File No: PRE-2006-001 Staff Planner: Lori Bowers
(To be filled in by City Staff)

Project Name: Heritage Estates, LLC

Review Comments

Heritage Estates - Pre-App

Sheet 3 (area to be sold back to the Morani)

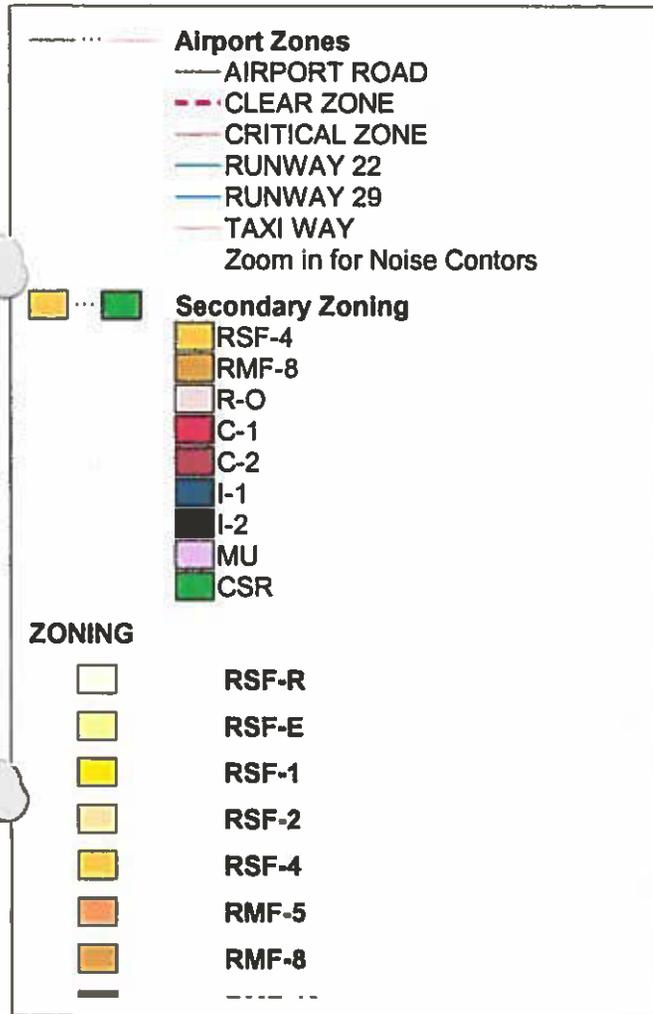
No plan for commercial

Phasing will be important.

100 lot minimum on stubs / one point of access.

30 " " " on dead end

Provide for F 3/4 Rd. on North.
